Subject: Reported Contamination at Milwaukee Die Casting Company, Inc.  
4132 N. Holton Street, Milwaukee, WI  
BRRTS Activity # 02-41-000023, FID # 241228240

The purpose of this letter is to notify Pharmacia and Fisher, the Responsible Parties (RPs), that additional environmental investigation and remediation of contamination at the Milwaukee Die Casting Company (MDCC) site are required for compliance with the hazardous substance spill law, Wis. Stat. § 292.11(3). An assessment of potential contamination above state regulatory standards in all environmental media is needed to determine the remedial actions necessary to restore the environment. Efforts to date, have focused primarily on investigation and removal of polychlorinated biphenyls (PCBs) and shallow chlorinated solvents contamination in soil. Limited groundwater investigation has been conducted, but remains incomplete.

Attachments: Figure B.3.b. – Groundwater Iso-Concentration Map [Pre-Soil Removal Action]  
Table A.1 – Groundwater Analytical Table [Pre-Soil Removal Action]

Drawing No. 12 – Extent of VOCs in Surface Soils  
Drawing No. 13 – Extent of VOCs in Deep Soils  
Figure 3-7 – Potentiometric Surface Map Septembe

PROJECT: CHW8271      FIGURE NO.: B.3.b.      DRAWING NO.: **B.3.b.**

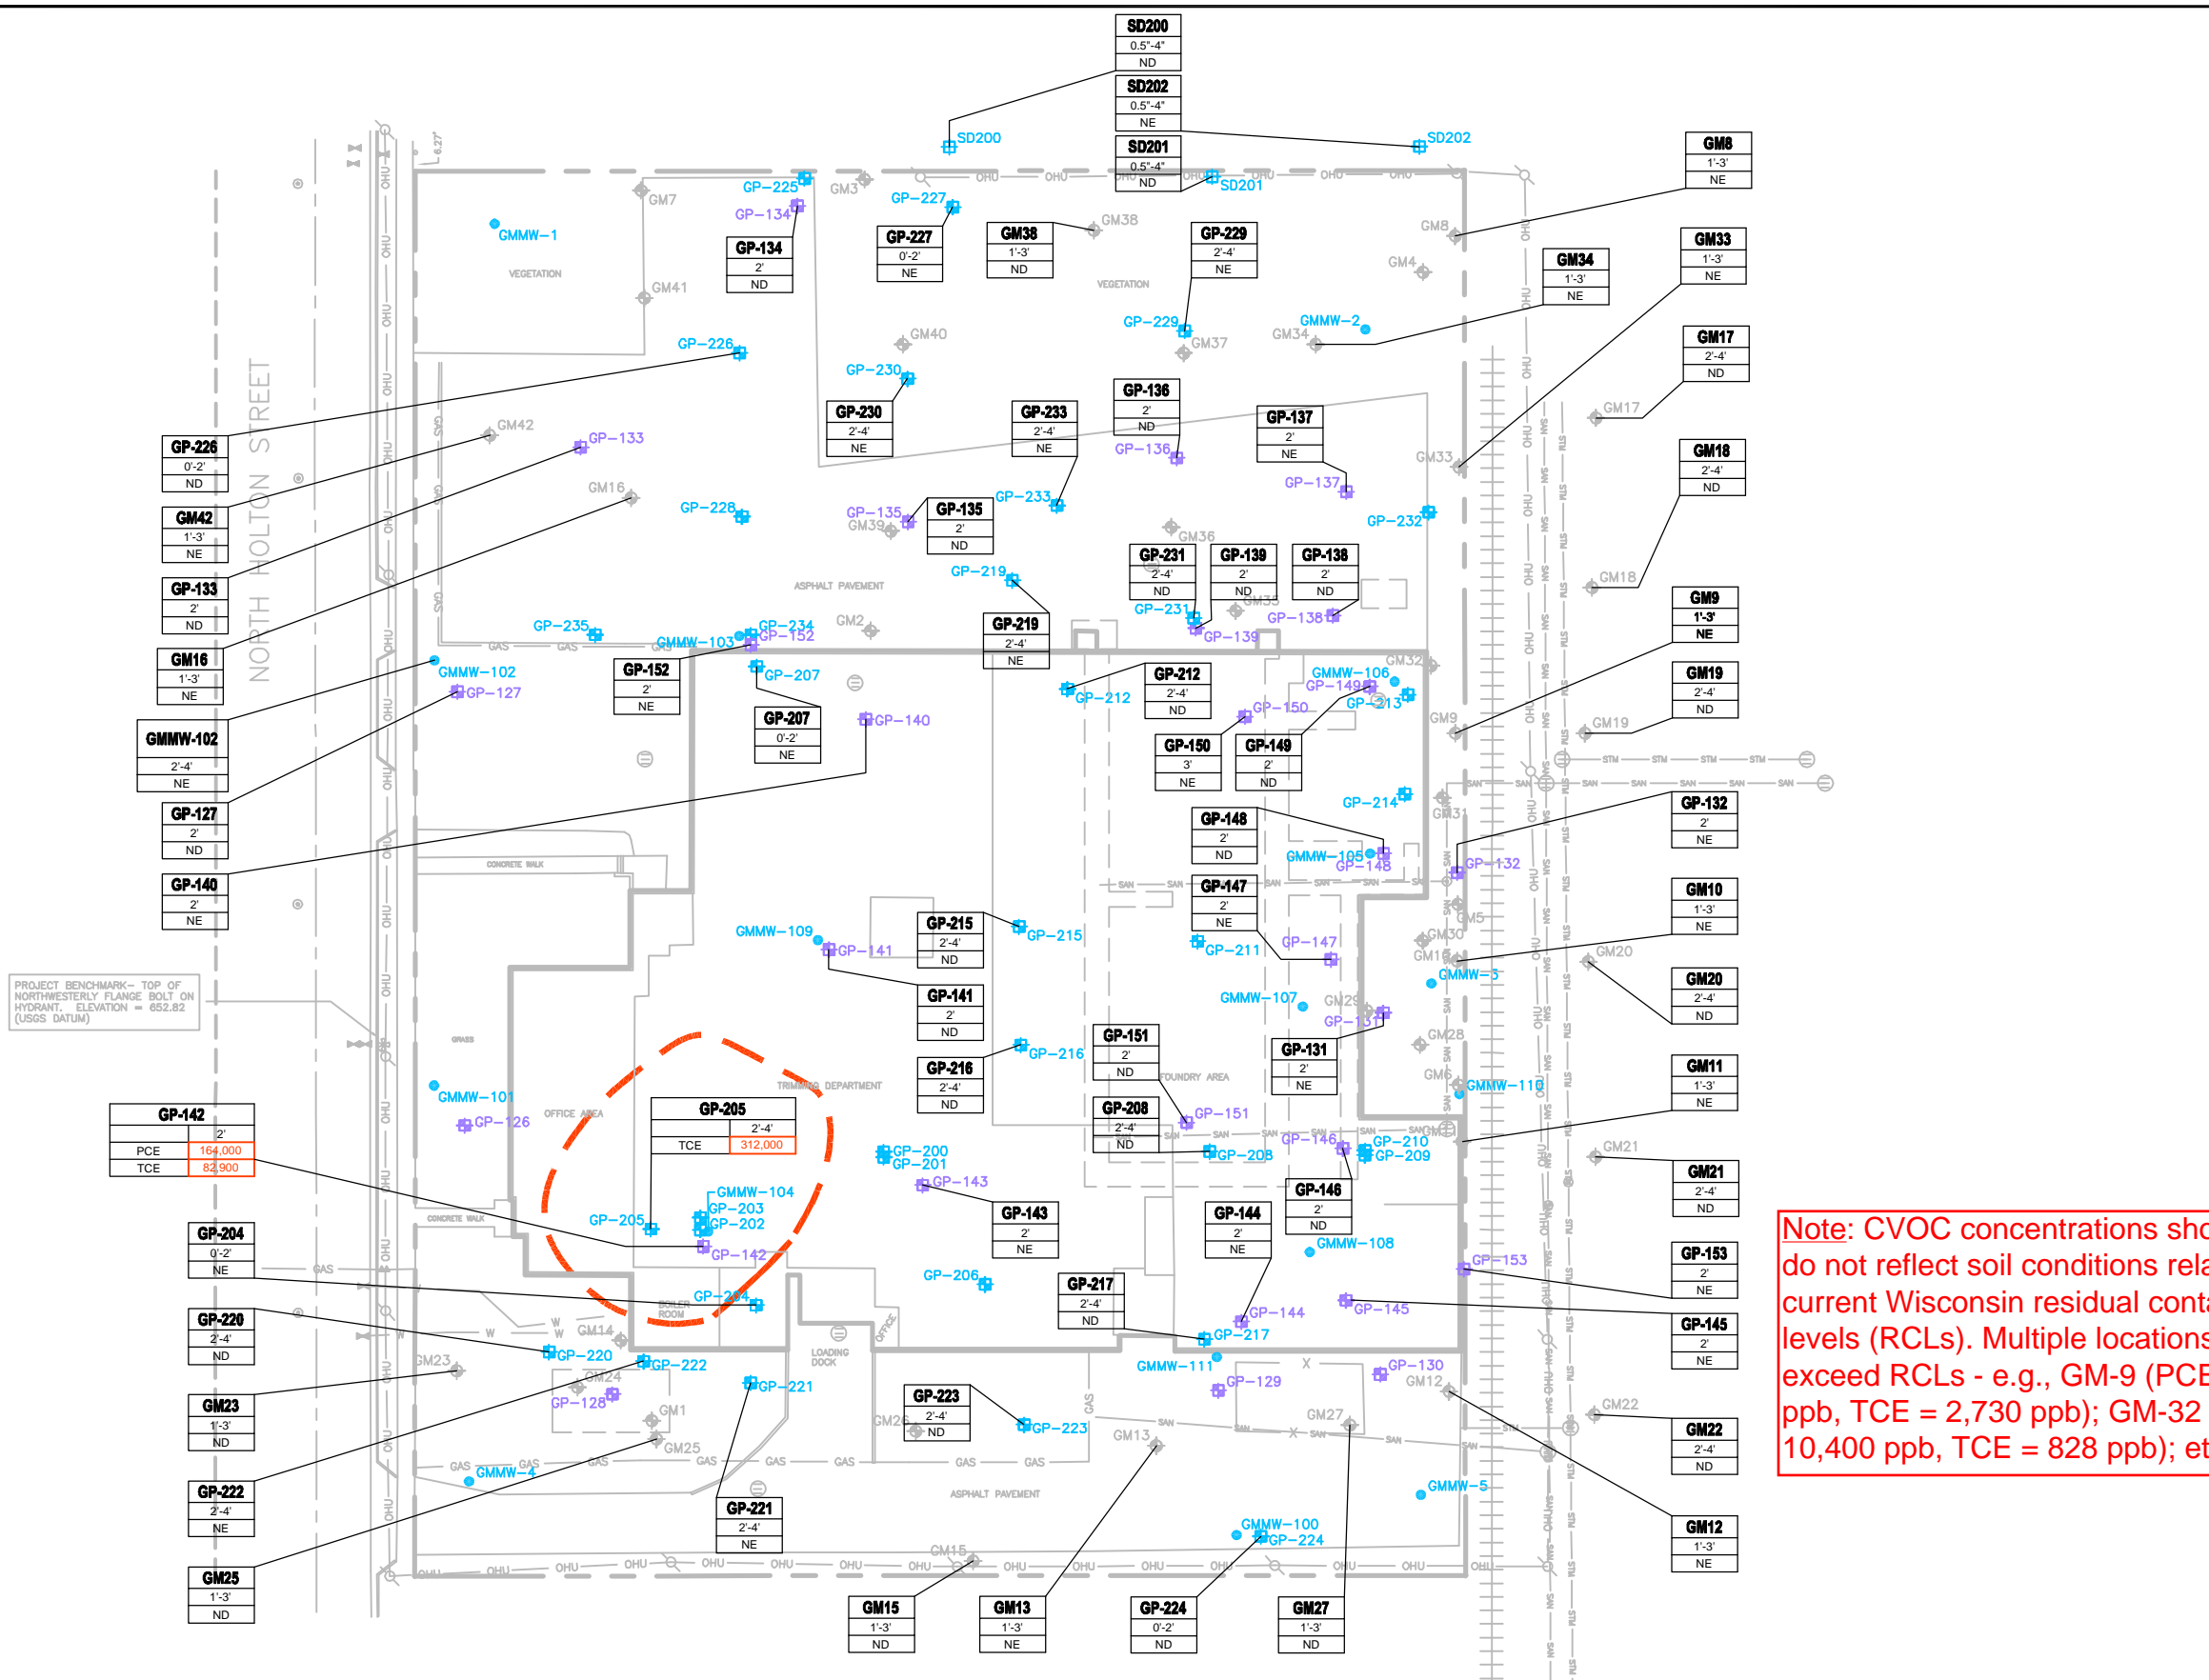
- The storm and sanitary sewer line trenches immediately to the east (downgradient) of the former MDCC facility property. The trenches may intercept and direct groundwater plume migration to the north, south, and/or northeast towards the storm sewer outfall to the Milwaukee River. Figure 3-7 Potentiometric Surface Map appears to reflect this situation by the abrupt decrease in CVOC concentrations from former monitoring wells GMMW-110 and GMMW-202 (west side of sewers) to GMMW-200 (east side of sewers). See previously mentioned Figure B.3.b.

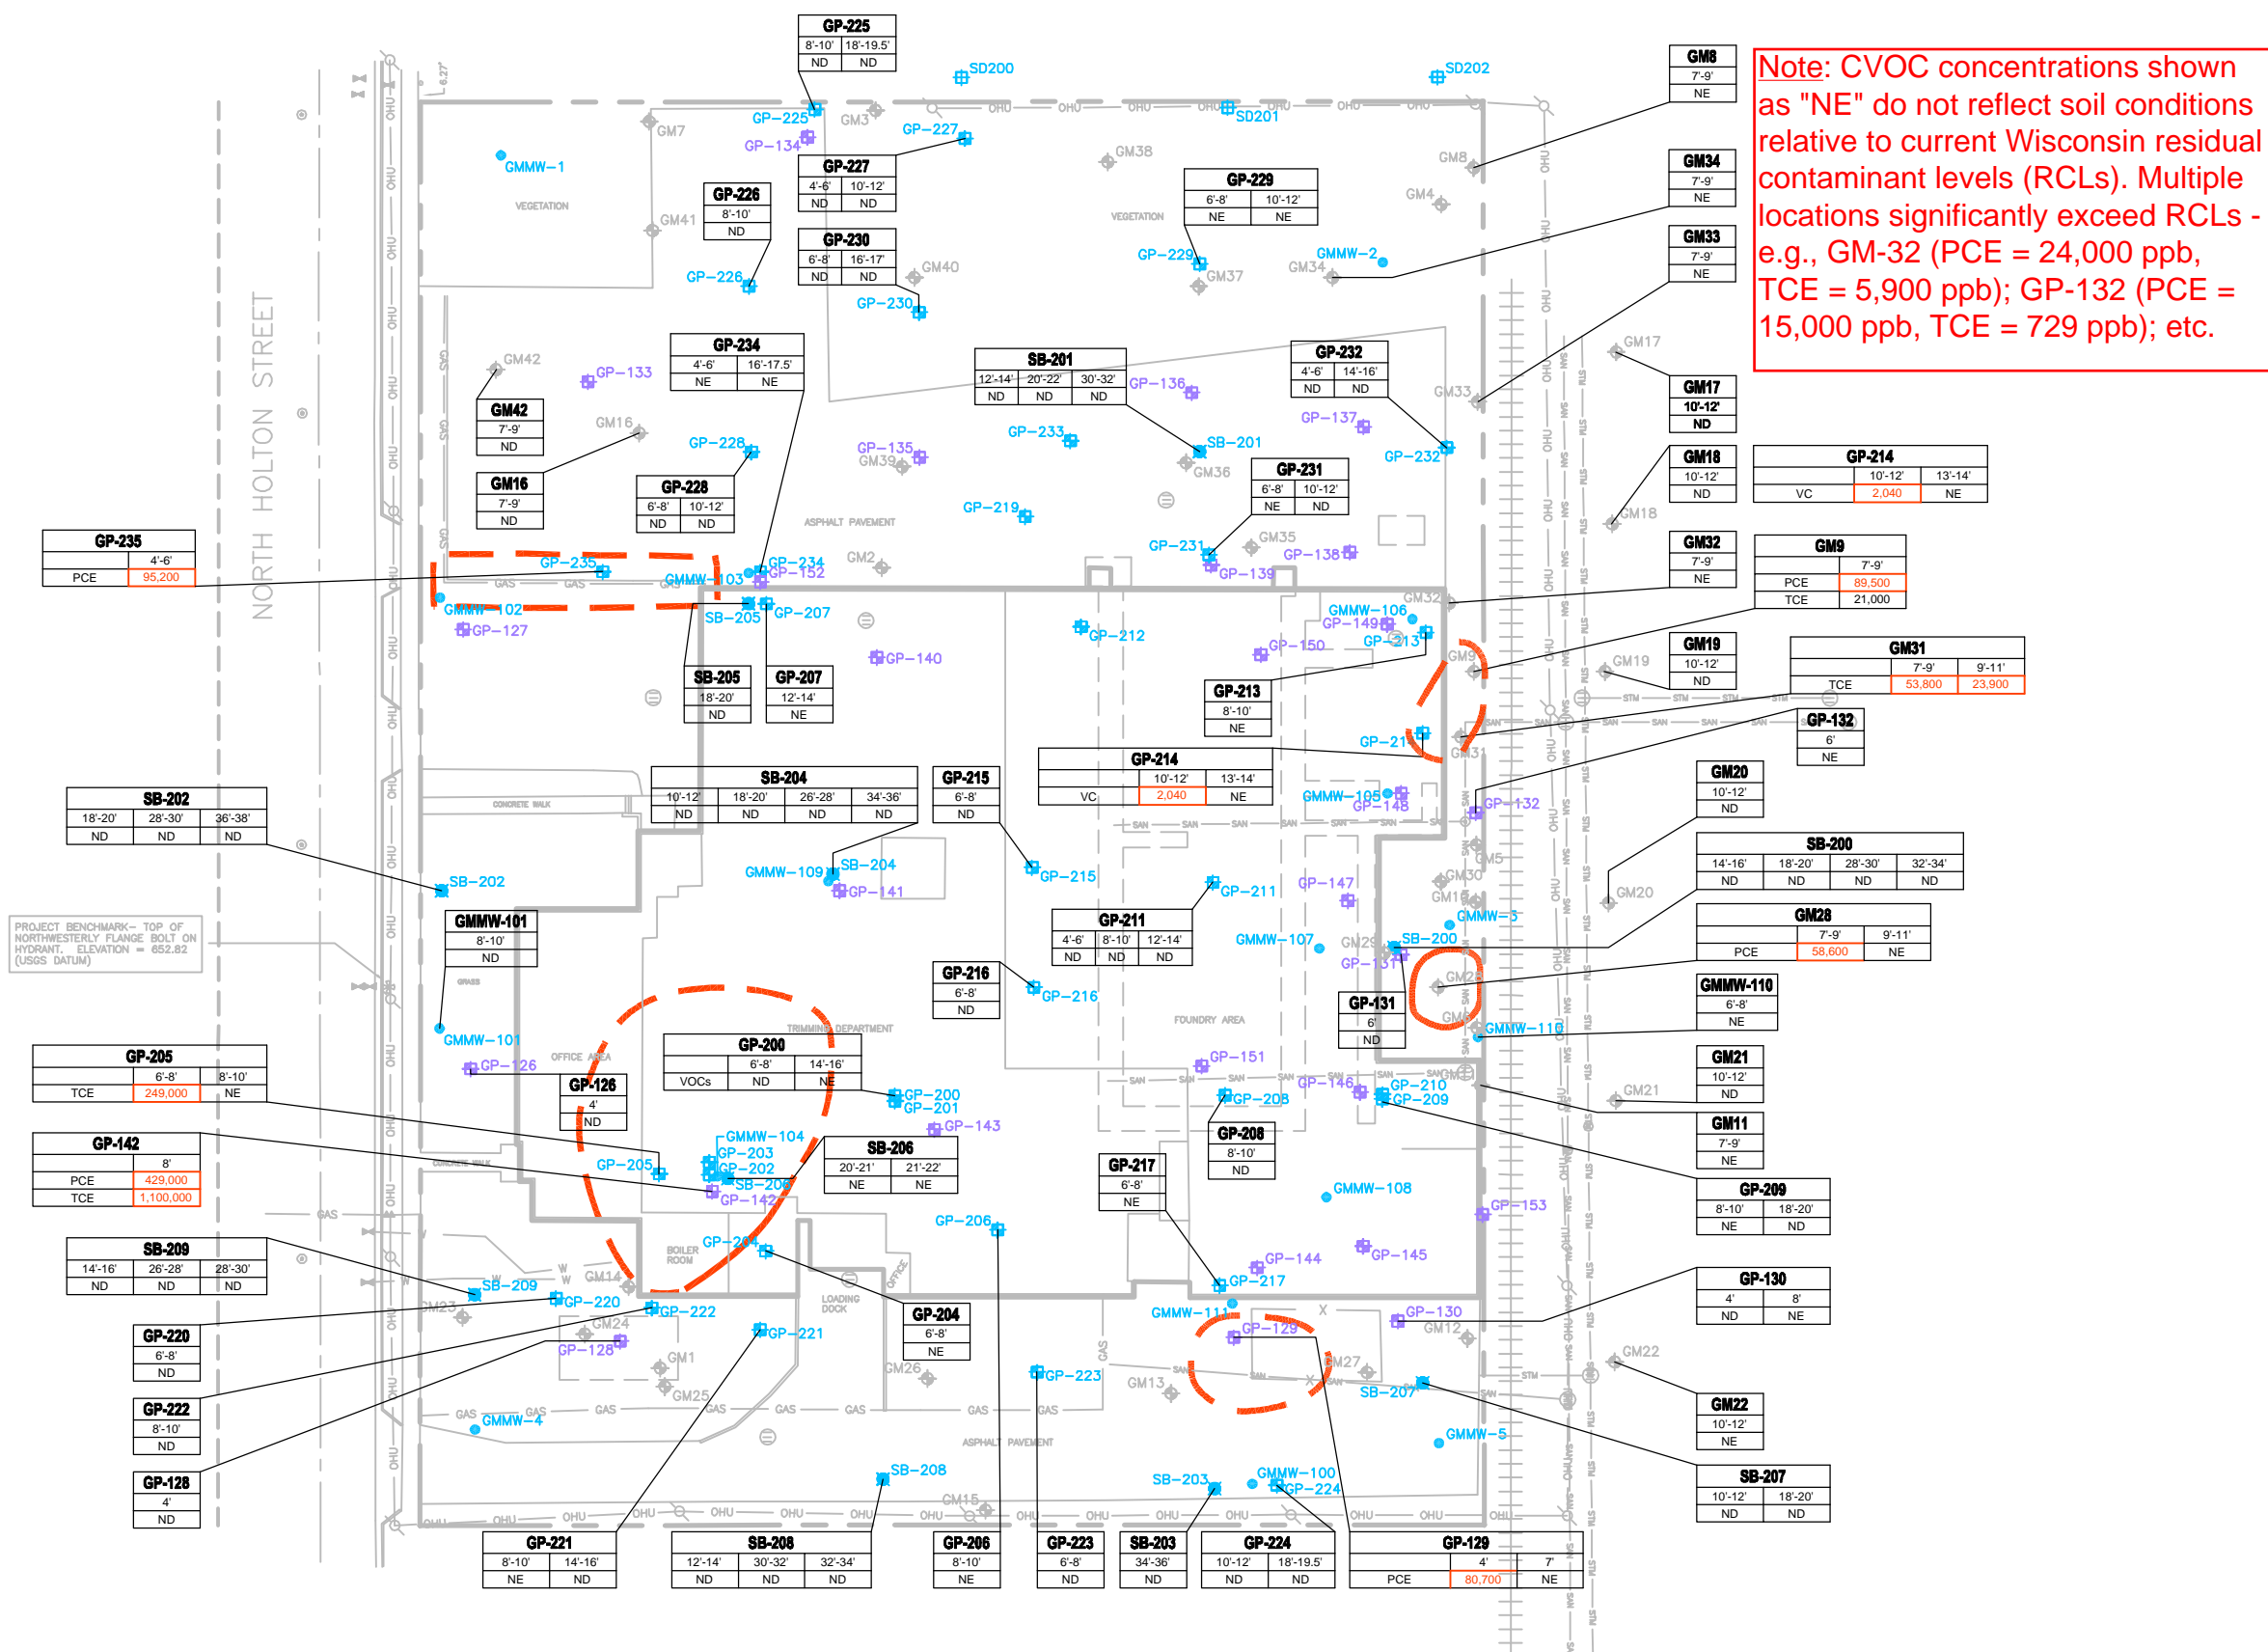
Refer to attached Drawing Numbers 12 and 13, which show concentrations in parts per billion, ppb. The generally higher concentrations at greater depths likely reflect the heavier-than-water (sinking) property of PCE and TCE compounds.

**Note:** CVOC concentrations shown as "NE" do not reflect soil conditions relative to current Wisconsin residual contaminant levels (RCLs). Multiple locations significantly exceed RCLs - e.g., GM-9 (PCE = 16,600 ppb, TCE = 2,730 ppb); GM-32 (PCE = 10,400 ppb, TCE = 828 ppb); etc.

**Red text-box notes inserted by WDNR 2018**
